# Access Compliance Report

## Public Rights-of-Way

### (Curb Ramps)

| Intersection ID: 10034711 | Main Street: POINDEXTER_DR | Cross Street: N/A       | Location:              | N                    |

| ADA ID: 7F3F24FF8F17      | Ramp Type: Perp            | Initial Pass/Fail: Fail | Overall Compliance: No | Severity Score: 12.5 |

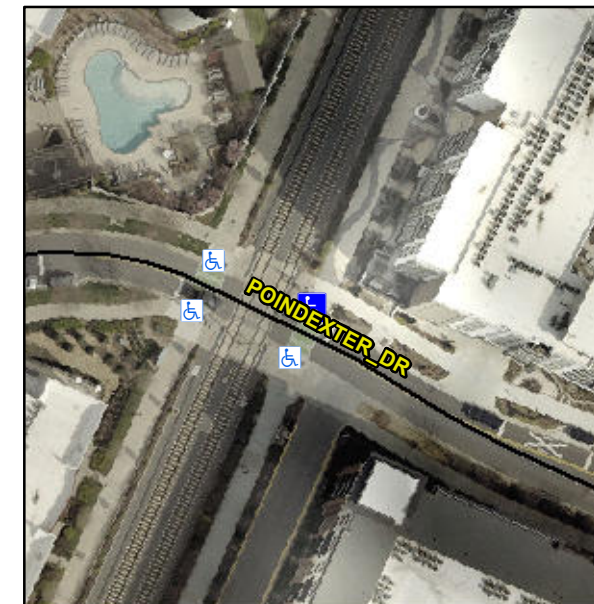
**Not Found, R304.2.2**

| Compliance | Description           | Data  | Compliance | Description                 | Data |
|------------|-----------------------|-------|------------|-----------------------------|------|
| N/A        | Ramp Length (in)      | 66.0  | No         | Ramp Slope (%)              | 9.2  |

**Remove & Replace Entire Ramp.**
